PLANNING COMMISSION
Regular Meeting
Monday, April 8, 2019
6:00 PM
Christine Nuernberg Hall

Agenda

EAST ELEVATION

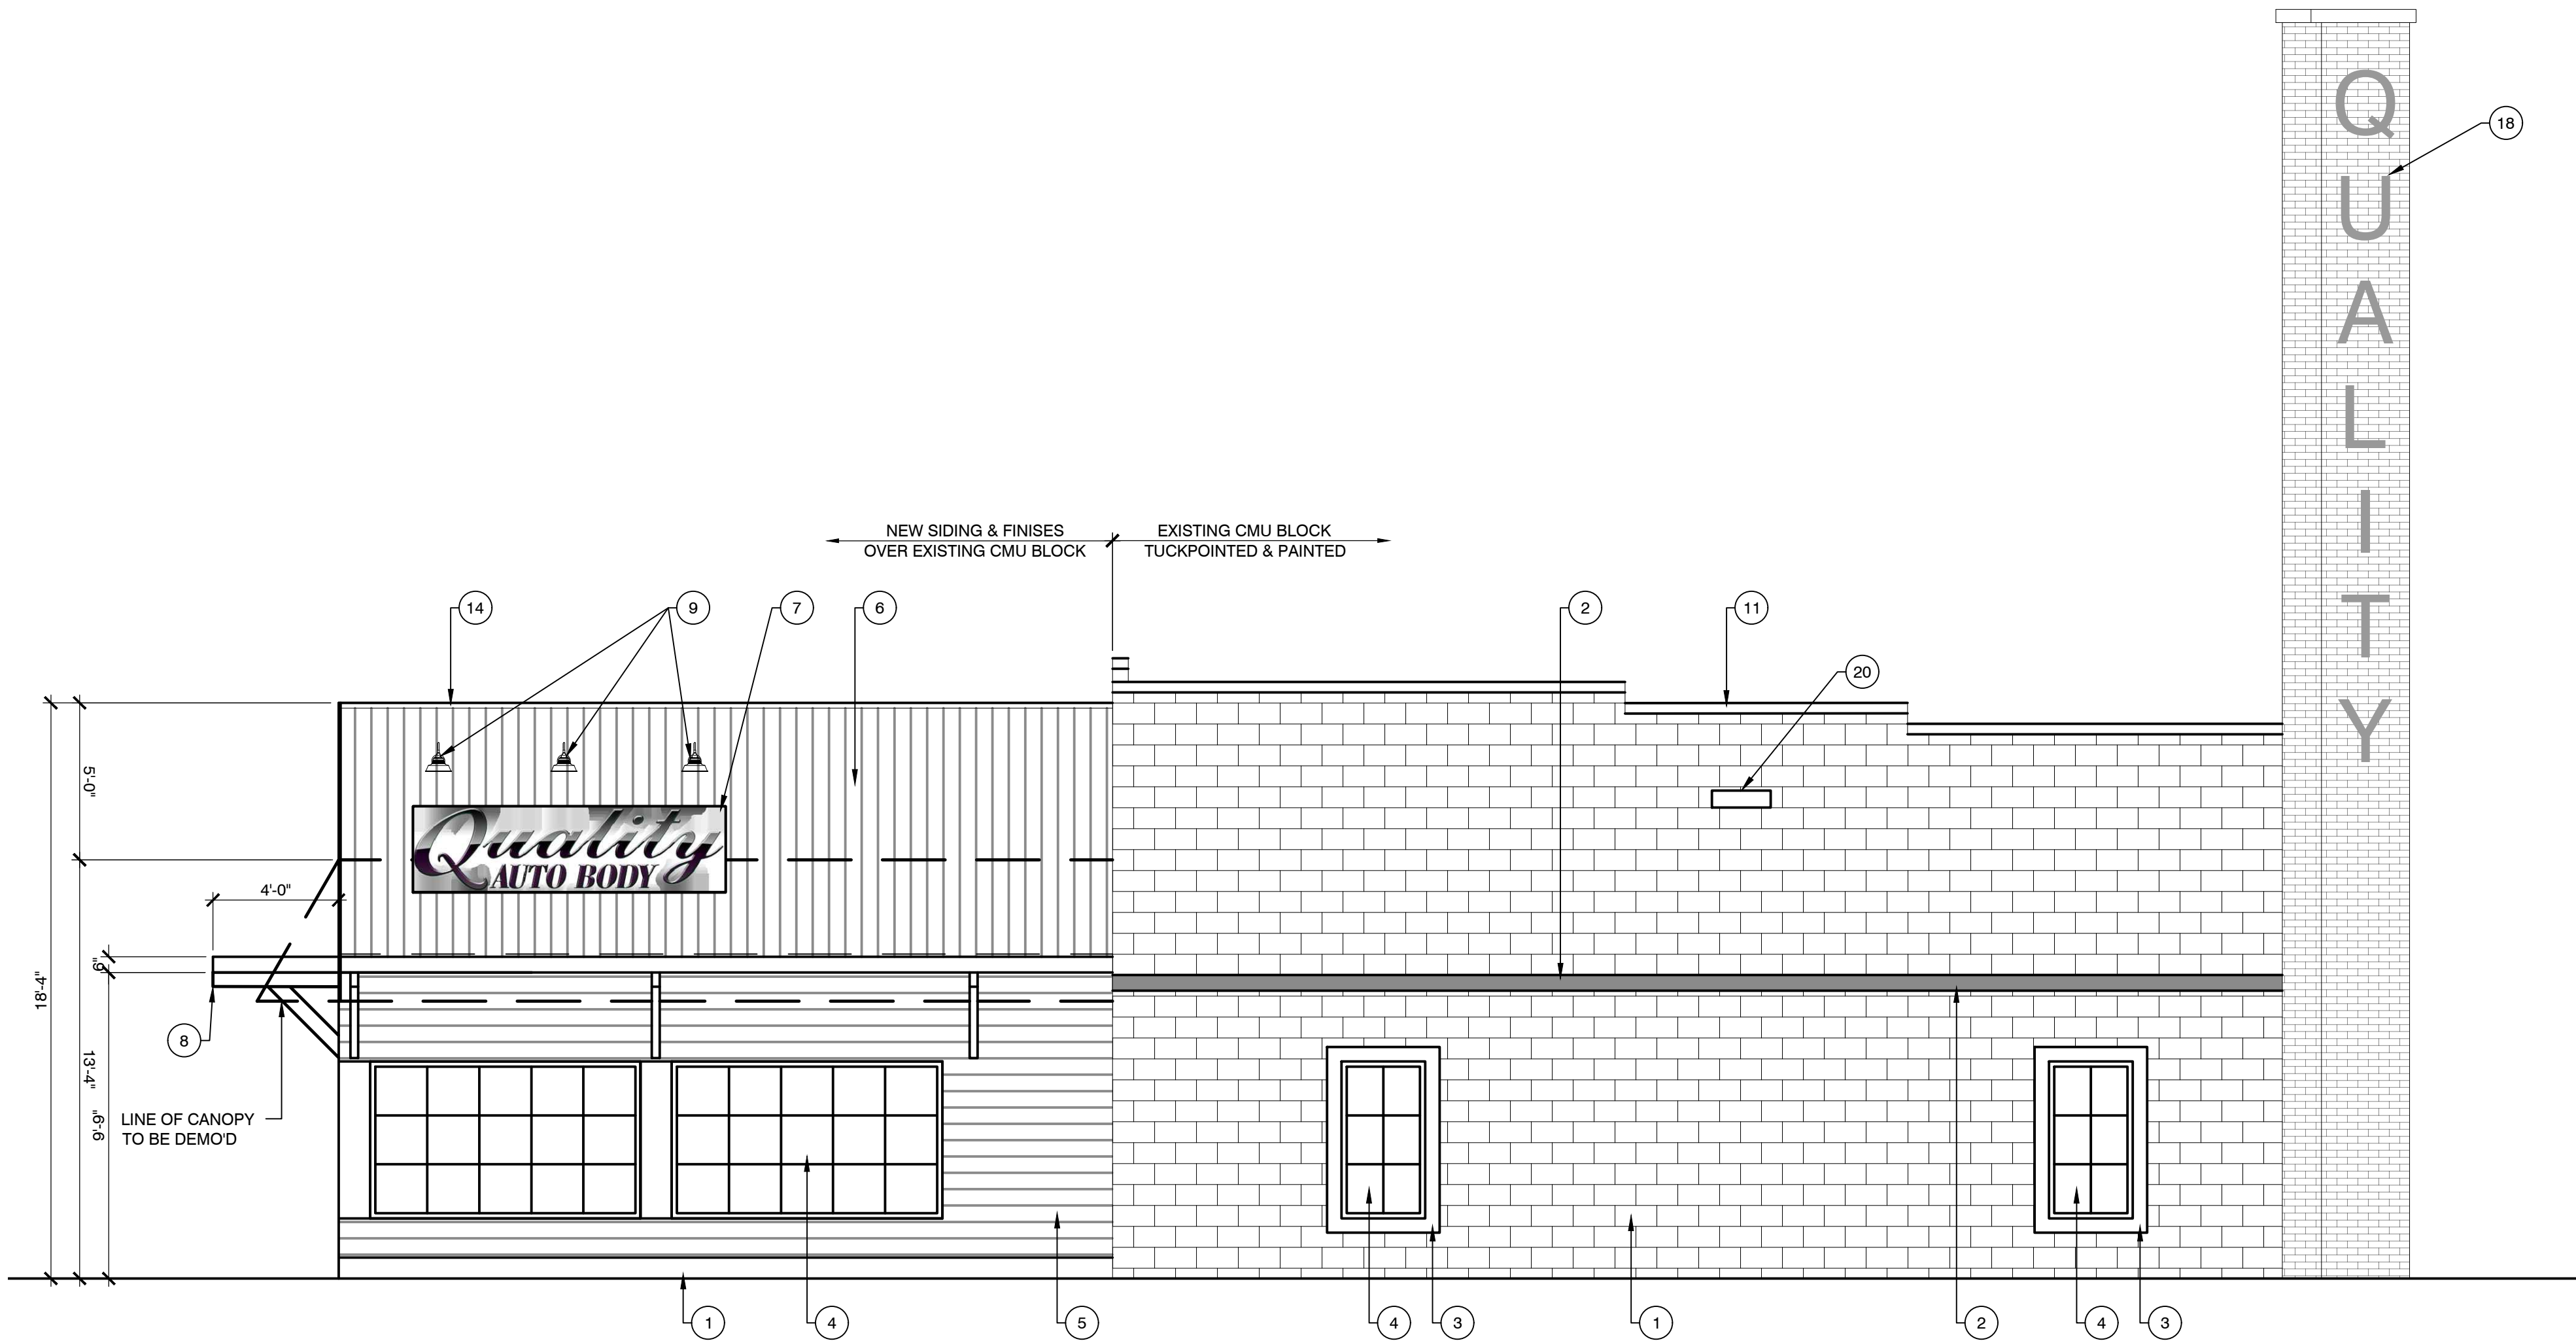
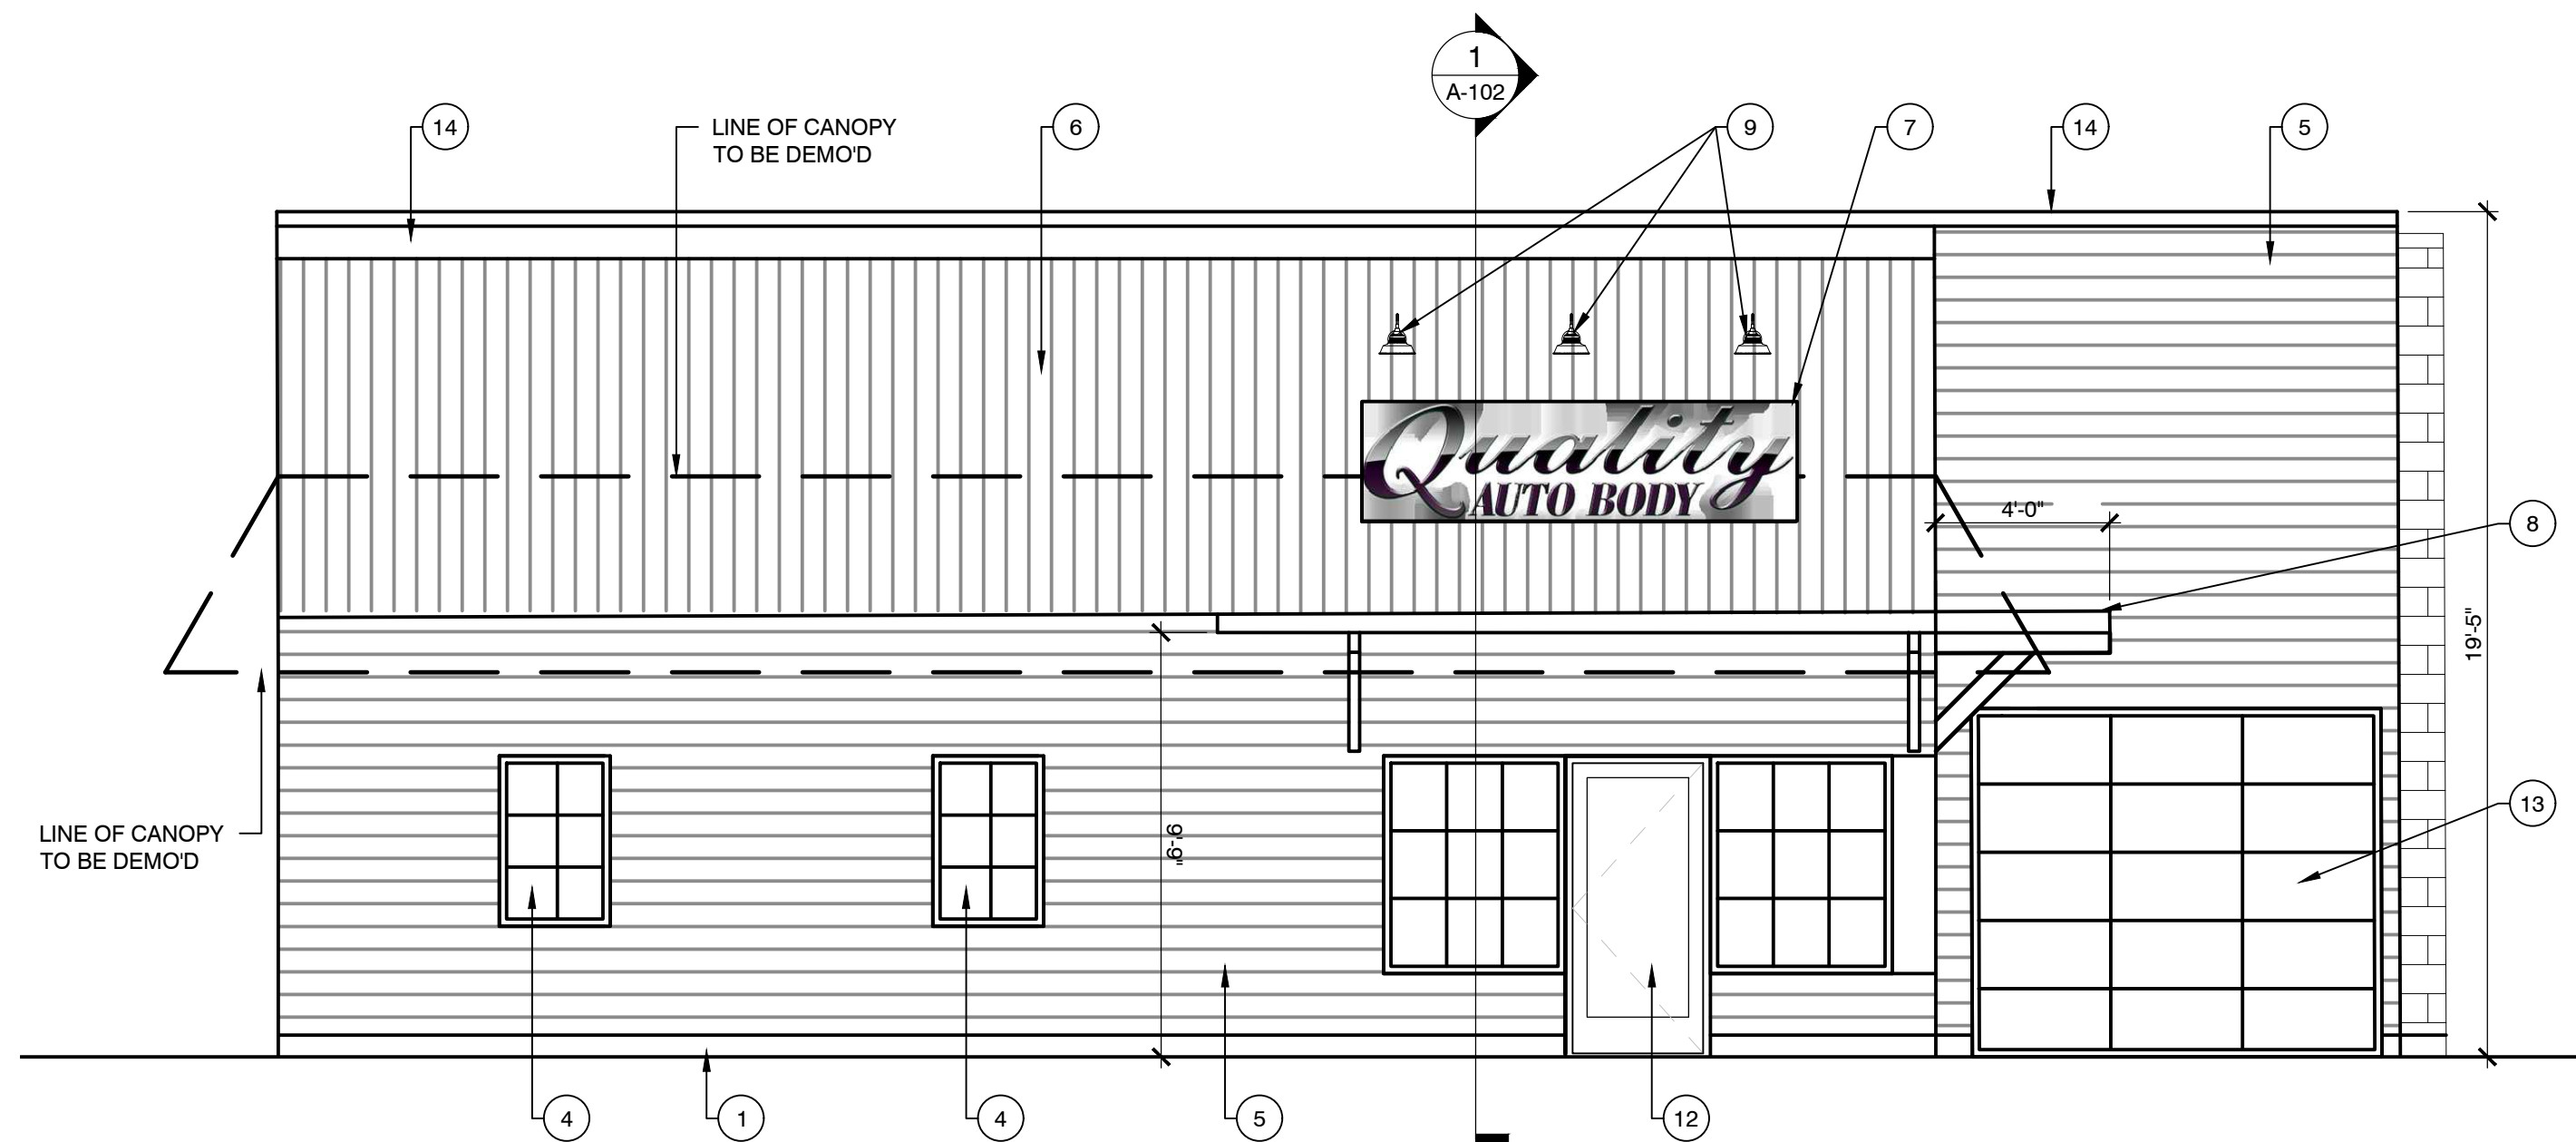
The proposed plan shows three wall signs for the building. There are wall signs shown on the east and north façade and a painted sign on the smokestack. For a single tenant building, the code allows one wall sign that does not exceed 2.5 percent of the wall area. In addition to the quantity of signs, the applicant is also requesting a waiver to the size of the signs. Based on the area of the

This request is similar to the request made by Associated Bank on Port Washington Road. As with the Associated Bank request, staff does not support the waiver for the two wall signs. Staff believes the applicant has other options to provide visibility to traffic in both directions. In the Town Center zoning district, the applicant has the option of a projecting sign. This type of sign would provide maximum visibility to traffic in both directions. If the applicant prefers the wall sign design, staff would not support the waiver for both signs. With regard to the size of the wall sign, staff is supportive of the waiver on either the north or east elevation. The size and shape of the building only permits a relatively small sign size. If the building was multi-tenant, the code would allow the signs to up 30 square feet in area. The 27 square foot sign is at an appropriate size and scale when compared to the overall building size.

5. The proposed Honey Locust shall be 3” in diameter at planting.
6. There shall be one wall sign located on either the north or east elevation not exceeding 27 square feet.

7. The smokestack sign design shall be modified to incorporate the ghosting technique. The applicant shall submit final plans for staff review and approval.

Sheet Title:
SITE IMPROVEMENTS
& EROSION CONTROL PLAN
Sheet Number:

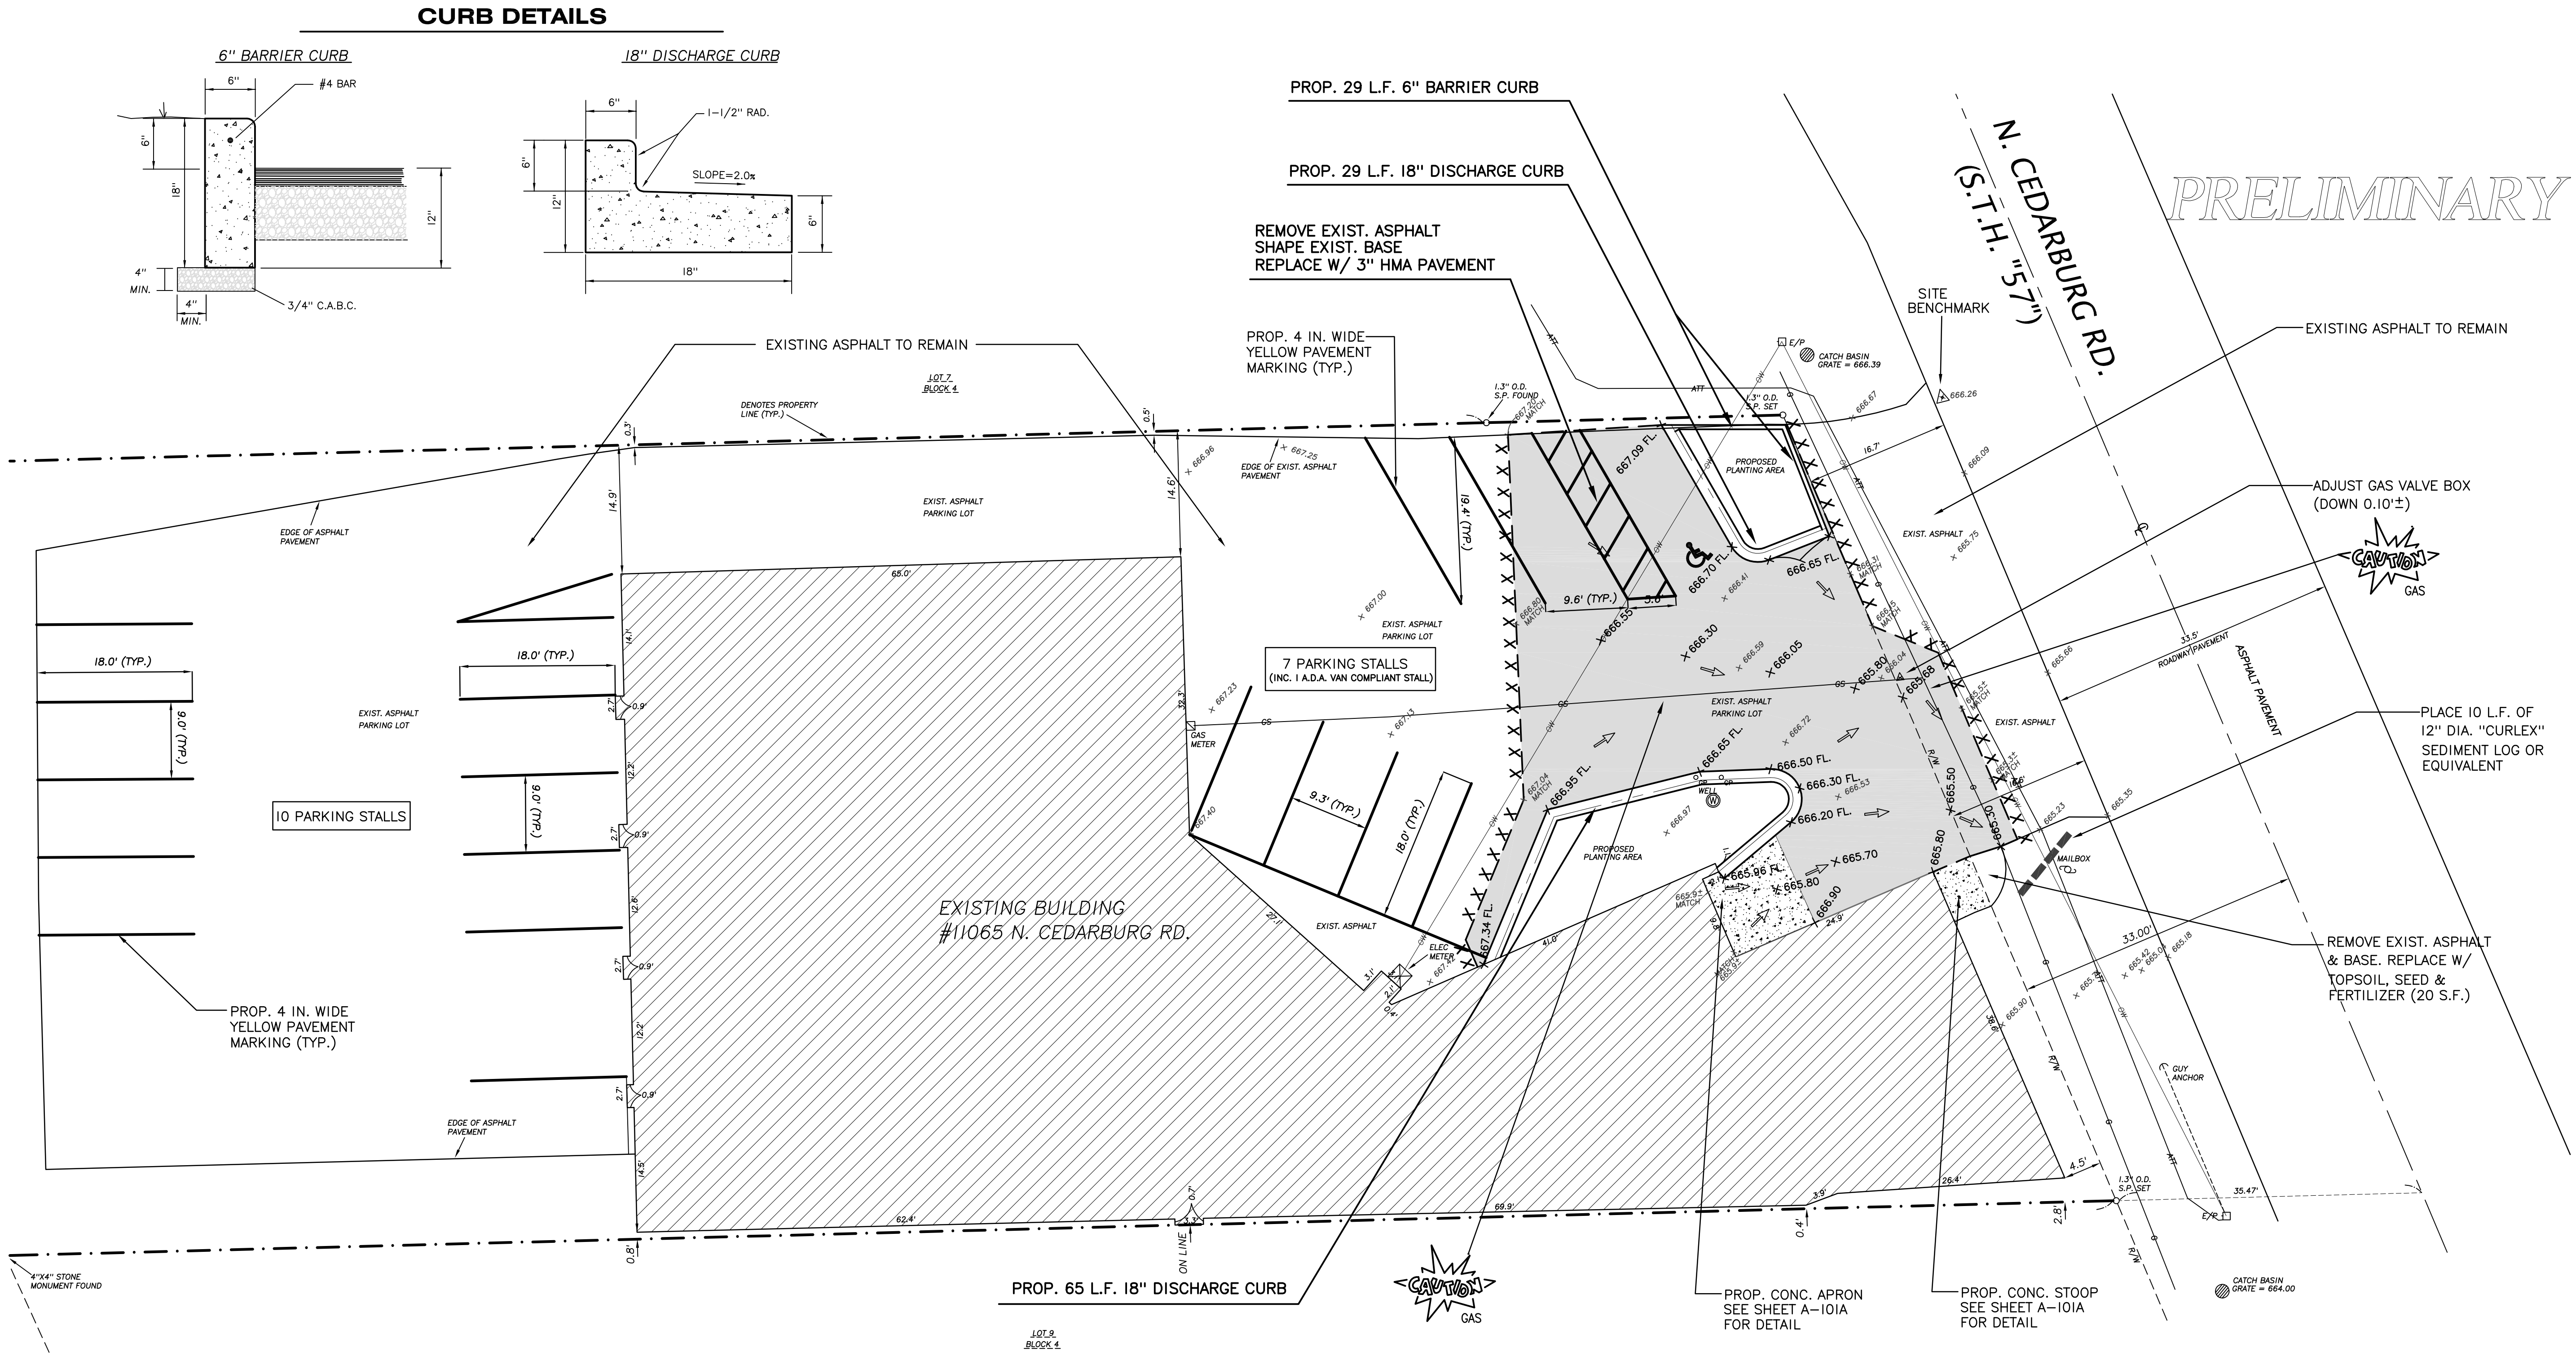
The site plan amendment includes replacing a portion of the asphalt parking lot at the front of the building, adding two landscape islands and restriping the parking lot. The added islands will reduce the parking lot entry and create a better delineation between the parcel and Cedarburg Road. While the changes are relatively minor, they will be a significant improvement to the look of the parcel from the public road.

The applicant has added two landscaped islands to the front of the parking lot. The plan includes one street tree along the north property line. The proposed Honeylocust is shown to be installed at 2" diameter. The code requires all street trees to be a minimum of 3" at the time of planting. Staff will add this as a condition of approval.
